RE: Case No. 16-1557-EL-BTX
West Bellaire-Glencoe 138 kV Transmission Line Project
Notice of Adjustments

After consulting with OPSB Staff, AEP Ohio Transmission Company, Inc. ("AEP Ohio Transco") provides the following notice of adjustments to structures associated with the above referenced Project.

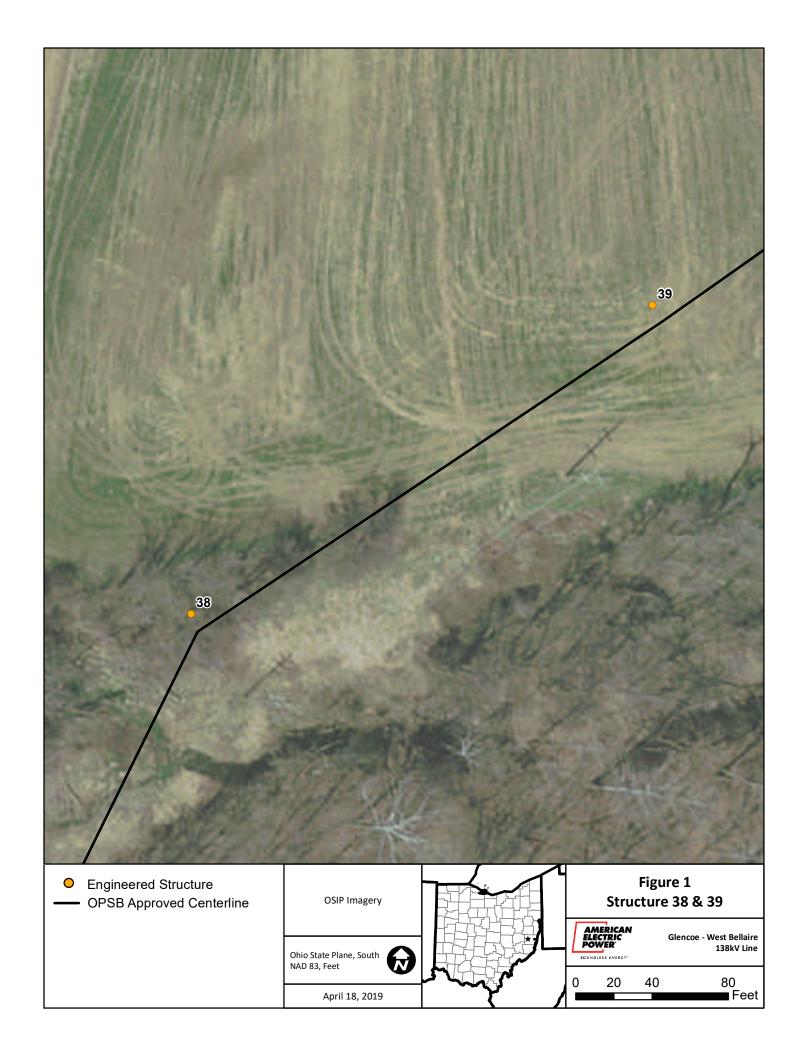
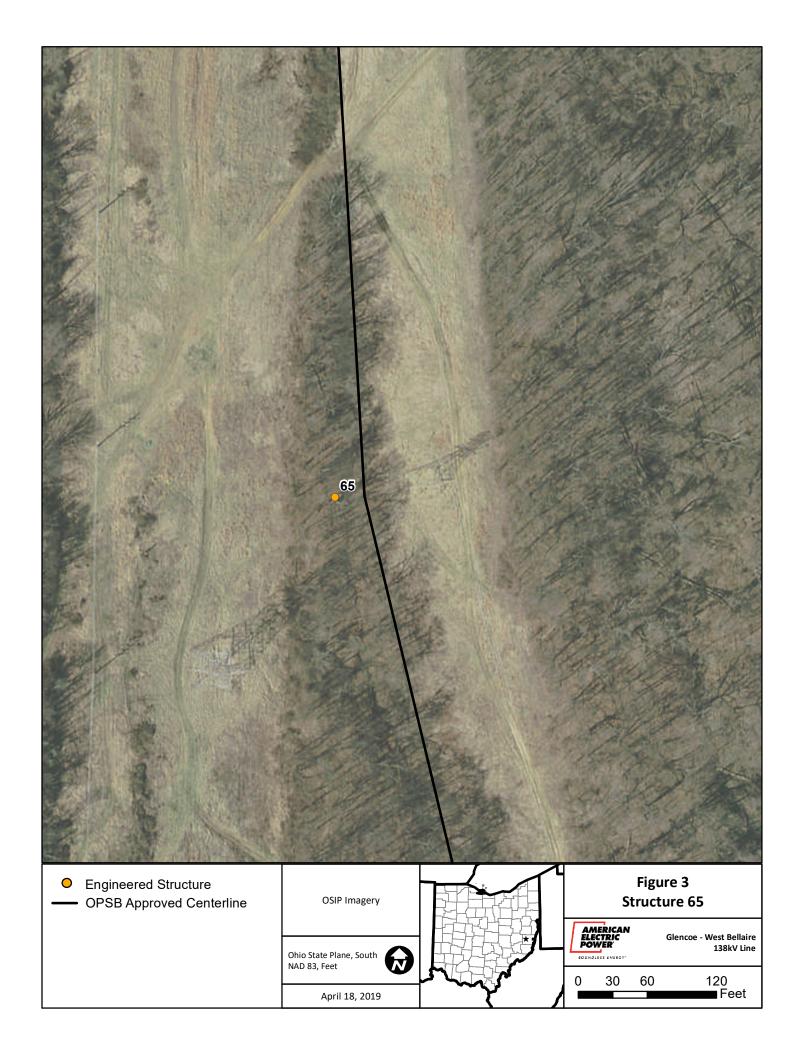
AEP Ohio Transco proposes to adjust 4 structures along the West Bellaire-Glencoe 138kV Transmission Line. Structure 55A will shift 20 feet north and Structure 65 will shift 25 feet west to obtain more clearance from a stream. Structures 38 and 39 will shift 10 feet north to avoid an abandoned mine discovered under their original locations. The proposed adjustments do not affect any new property owners, require any additional tree clearing, require any new right-of-way, or impact additional wetlands or streams.
